Proposed modifications to section 9.3 shown below

9.3 The stratified event scheduler

<NEW FIG 9.1> (Added Pre-Re-NBA, Re-NBA, Post-Re-NBA regions to figure)

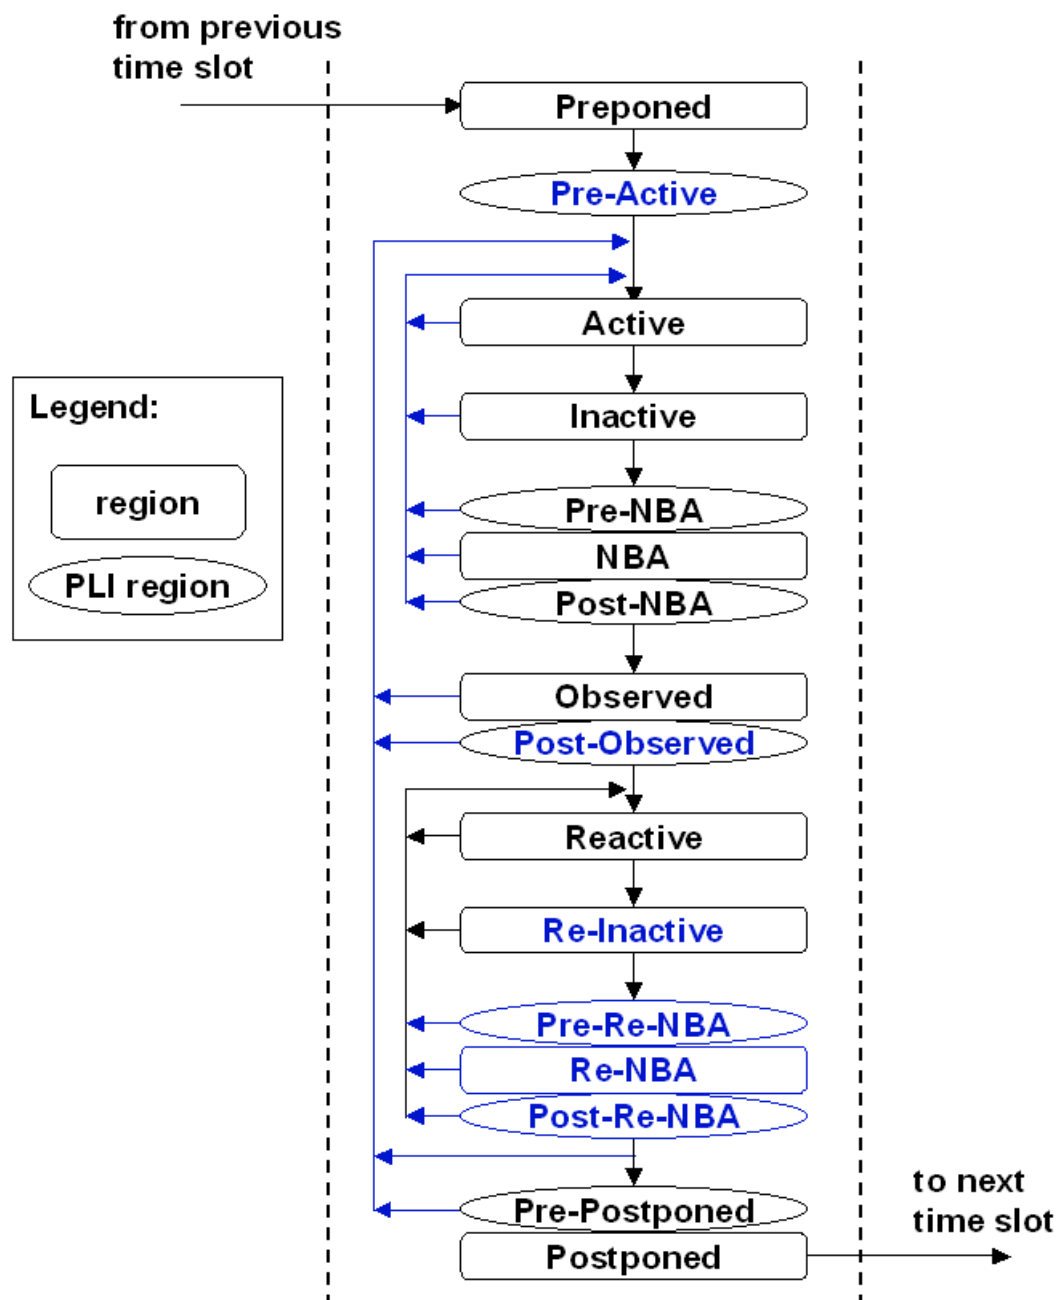
The **Pre-Postponed** ~~Pre-postponed~~ region provides a PLI callback control point that allows PLI application routines to read and write values and create events after processing all other regions except the Postponed region. The flow of execution of the event regions is specified in Figure 9-1.
